Item 4.**Development Application: 141-155 Commonwealth Street, Surry Hills - D/2024/122**

File No.: D/2024/122

Proposal Summary: The application seeks development consent for the demolition of the existing structures (excluding substation), excavation, and construction of a Part 5 - Part 6 storey commercial building with basement and landscaped rooftop terrace.

Figure 31: Typical floorplan of units on south-east side of 74-80 Reservoir Street

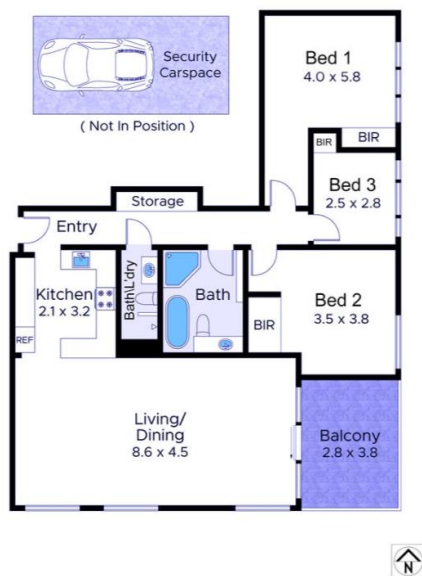
99. Whilst the majority of the overshadowing impacts are to bedroom windows, the proposed development will also restrict solar access to east-facing balcony openings on the south-east corner of the building to less than 2 hours on 21 June.

100. Typical floorplans of these apartments and the affected balcony openings are shown in Figures 31 and 32 below.

Figure 33: 18m LEP height plane with portion of rooftop parapet causing overshadowing to balcony opening of 74-80 Reservoir Street indicated

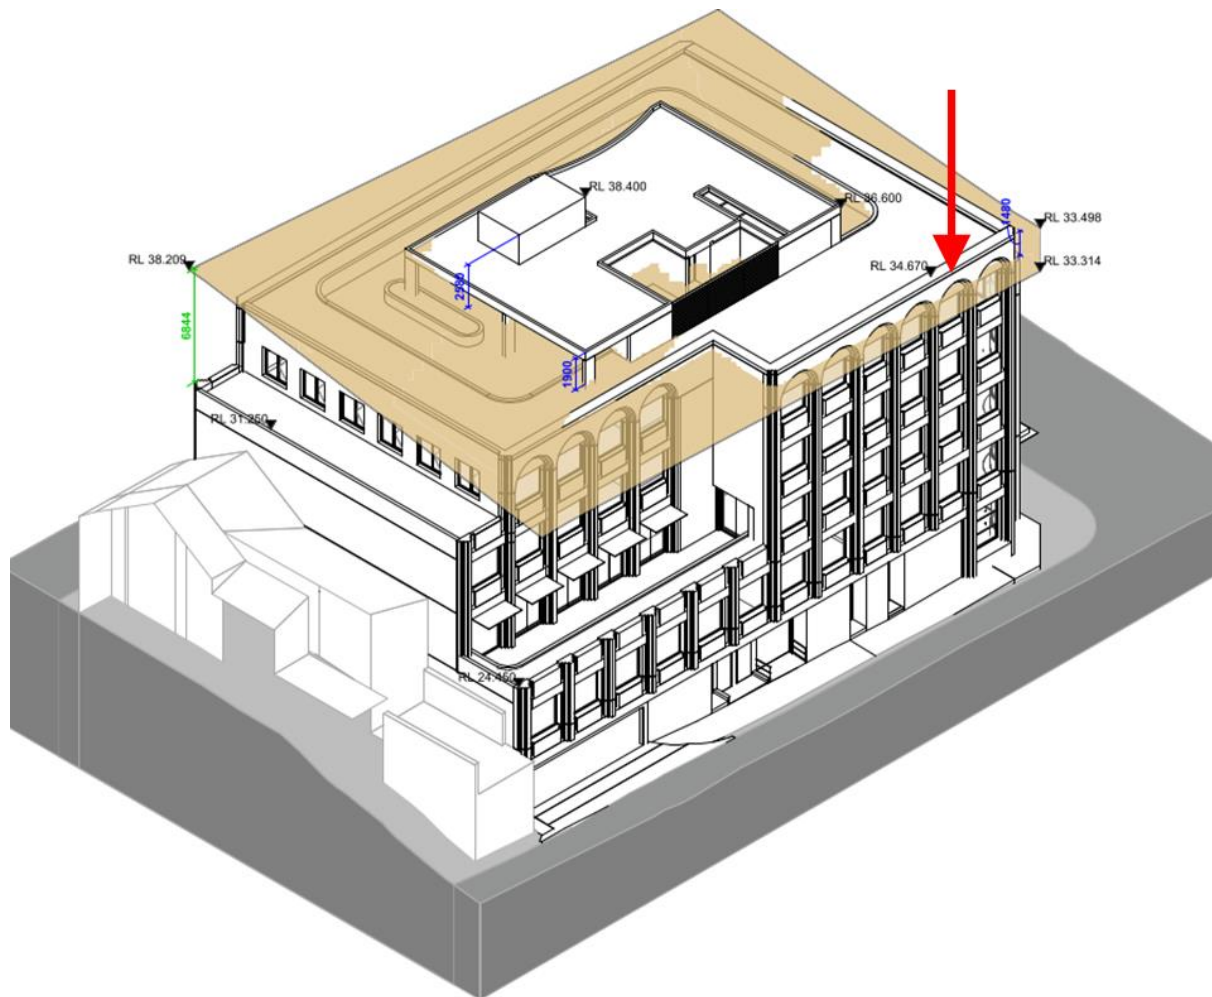
101. Units 2 and 10 are particularly vulnerable to overshadowing due to their lower level and the narrow width of Beauchamp Lane, which provides only approximately 2.94m of separation between 74-80 Reservoir Street and the subject site.
102. Strict numerical compliance with controls to protect these openings would significantly limit the development potential of the site, noting that the proposed development's exceedance of the LEP height control does not further impact solar access to these openings.
103. It is acknowledged that solar access to the balcony of Unit 18 at Level 3 of 74-80 Reservoir Street is partially affected by the rooftop parapet at the south-west side of the site. This aspect of the development breaches the LEP height control, as illustrated in Figure 33 below.

104. The section of the parapet that exceeds the permitted height limit marginally reduces solar access to the balcony of Unit 18, constraining direct sunlight for an approximately 30 minute period on 21 June and the minor breach of the LEP height restriction will not have a significant impact upon residential amenity.
